Product Change Notice (PCN)

Subject: Carrier tape change for Intersil Product ISL98611II56Z-T WLCSP Packaged Product

Publication Date: 7/15/2015

Appendix A – Carrier Tape Dimension – PCN15038

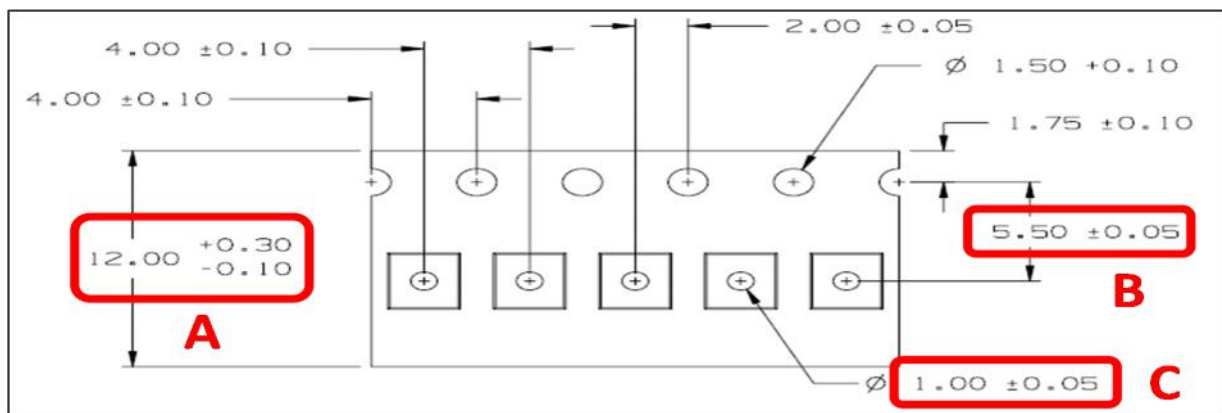
Existing Carrier tape (8mm)

New Carrier tape (12mm)

#	Code	Dimension	Existing Carrier Tape	New Carrier Tape
1	A	Carrier Tape Width	8.00 mm + 0.30 mm - 0.10 mm	12.00 mm + 0.30 mm - 0.10 mm
2	B	Index Hole to Pocket Hole Width	3.50 mm ± 0.05 mm	5.50 mm ± 0.05 mm
3	C	Pocket Hole Diameter	0.60 mm ± 0.05 mm	1.00 mm ± 0.05 mm
